*TOLEDO CITY  
PLAN COMMISSION  
REPORT*

*JUNE 11, 2015*

| 1. Z-4001-15 & M-8-15: | Zone Change from RS6 to IC and adoption of Master Plan at 5601 Clegg Drive (bh)                   |

**C3**

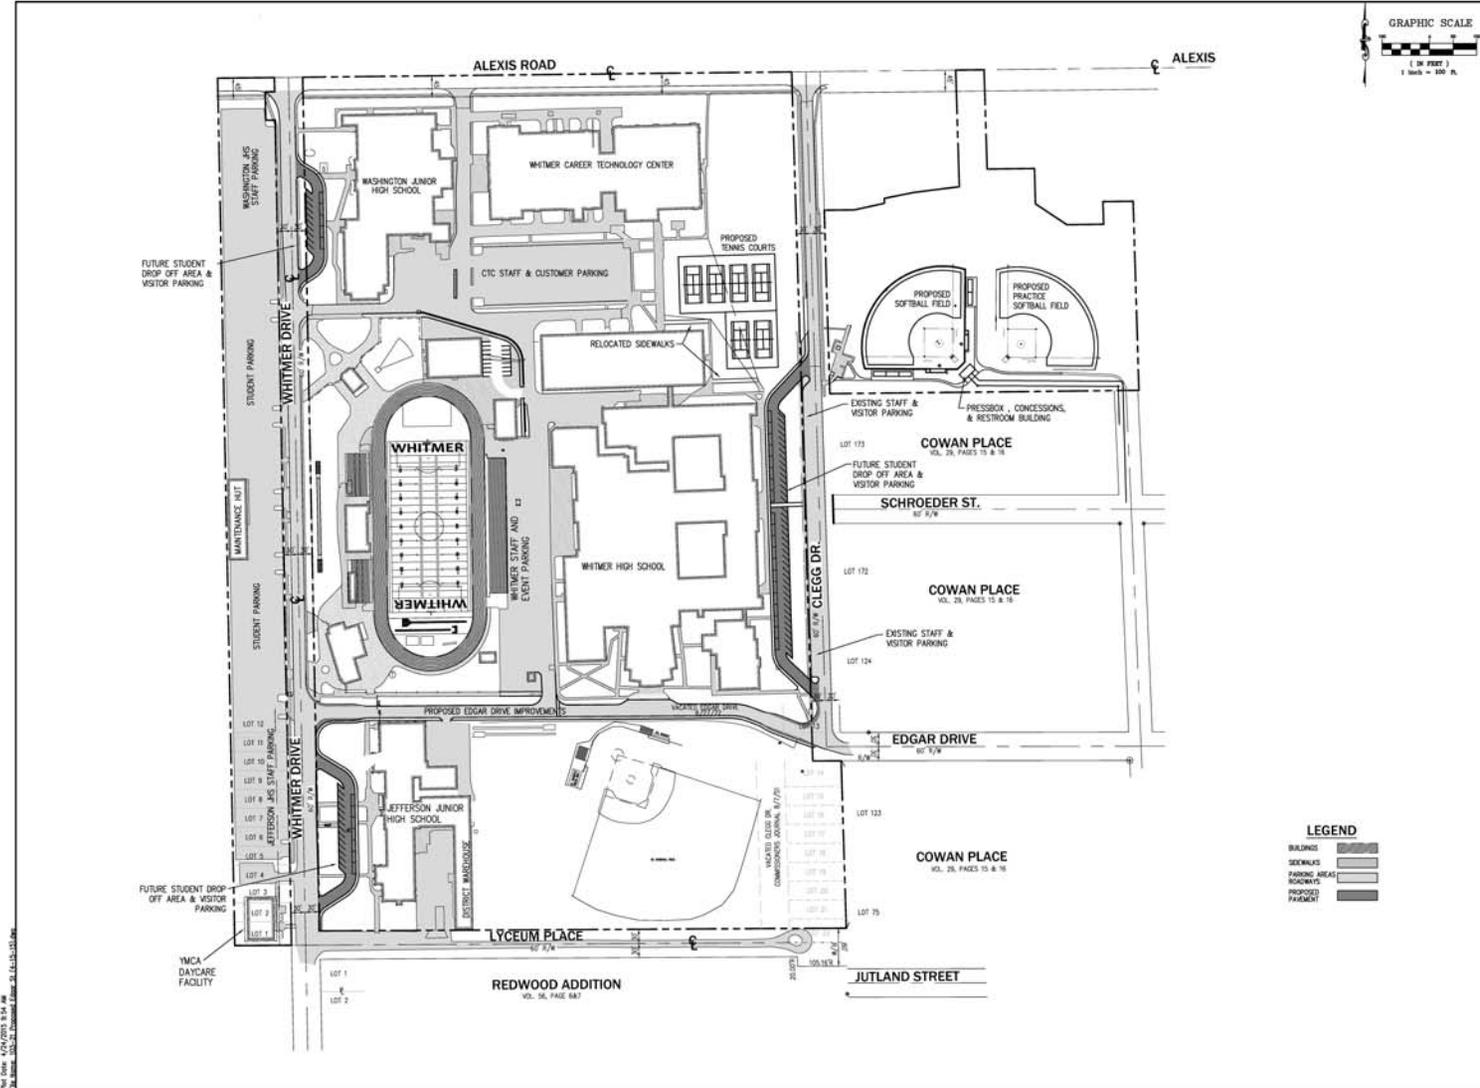
4. Plans for new water services or modifications to existing water services shall be submitted to the Division of Engineering Services for review and approval.
5. If existing public water facilities are in conflict and must be relocated, they will be relocated by the City of Toledo at the applicant's cost.

8. Plans submitted indicate earth-disturbing activity greater than 2,500 square feet; therefore, a detailed site-grading plan for this project shall be submitted for storm water approval. No construction work, including grading, will be permitted without approved plans and inspection.

24. The future Edgar Drive improvements and the future student drop off areas are a result of the workshop and long term traffic evaluation by the District. The intent of these improvements is to reduce speed on Edgar, provide designated walkways for pedestrians and provide designated drop off areas for students. Additional improvements will be considered as the safety review process moves forward.

27. A sidewalk will be added to the Master Plan along Whitmer Drive in front of Jefferson Junior High and is planned to be constructed in 2016.
28. The existing parking lots will be evaluated for potential improvements in accordance with TMC 1107.

30. Each project (softball complex, Edger Drive improvements, and student drop-off zones) will require minor site plan review to determine compliance with the City of Toledo Municipal Code minimum standards (design standards, drive aisle and parking stall widths, etc...).
31. Each site plan review will require a detailed site, lighting, sign, fencing and landscaping plan shall be submitted to the Plan Director for review and approval. Such plan shall include:
  - a. The location, number, height, diameter and species of any materials to be planted and maintained, as well as the location and number of any existing trees to be retained, trees, shrubs, and landscape materials shall meet the standards included in TMC 1108.0400 Landscape Materials Standard.
  - b. The location, height and materials of any fencing to be installed and maintained.

SITE PLAN  
SCALE 1" = 20' 0"

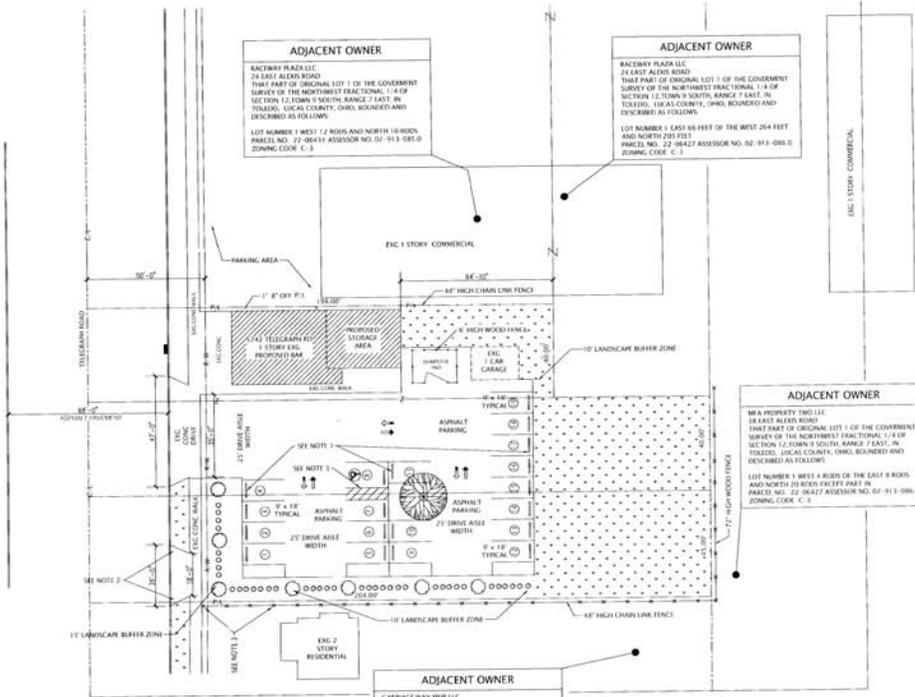
The applicant will be required to provide landscape islands at the end of each parking row. Landscape islands are required to provide both tree and shrubs as part of the internal parking lot landscaping requirements; in addition the island will be required to have grass, mulch or other vegetative ground cover. Foundation plantings are also required along all main and secondary entrances of the building that are visible from the public right of way. A landscape plan indicating compliance with these requirements is listed as a condition of approval.

29. A detailed landscaping plan shall be submitted to the Plan Director for review and approval. Such plan shall include:
  - a. All parking spaces must be within 100 linear feet of a landscaped area.

- b. Type "A" Landscape buffer is required along the southern and eastern property lines, a ten (10) foot wide Type "A" Buffer with a board-on-board fence shall installed and include four (4) trees and twenty (20) shrubs for every 100 Linier feet of property line; **shall be noted on revised plan.**

- c. All landscaped areas must have a minimum dimension of at least 9 feet and be at least 160 square feet in area; **shall be noted on revise plan.**

- d. Foundation plantings are required along all main and secondary entrances of the building that are visible from the public right of way, and landscaping at all major building entrances. (TMC 1108.0205.B Landscaping and Screening; **shall be noted on revise plan.**

- e. Topsoil must be back filled to provide positive drainage of the landscape area; **shall be noted on revise plan.**
  - f. Landscaped areas may not contain bare soil, aggregated stone or decorative rock. Any ground area must be covered with hardwood mulch, grass or other vegetative ground coverage; **shall be noted on revise plan.**

- g. Landscape terminal islands must be provided at the end of each parking row; **shall be noted on revise plan.**
  - h. Two canopy trees and six shrubs are required to be installed in interior landscape areas for each 10 parking spaces within the parking lot; **shall be noted on revise plan.**

- i. The location, number, height, diameter and species of any materials to be planted and maintained, as well as the location and number of any existing trees to be retained, trees, shrubs, and landscape materials shall meet the standards included in TMC 1108.0400 Landscape Materials Standards; **shall be noted on revise plan.**

- j. The location, height and materials of any fencing to be installed and maintained; **acceptable as depicted on landscape plan.**
  - k. The location, type and direction of any proposed lighting. The lighting is subject to the approval of the Director of the City of Toledo Plan Commission (lights are to be directed away from adjacent residential properties); **shall be noted on revise plan.**
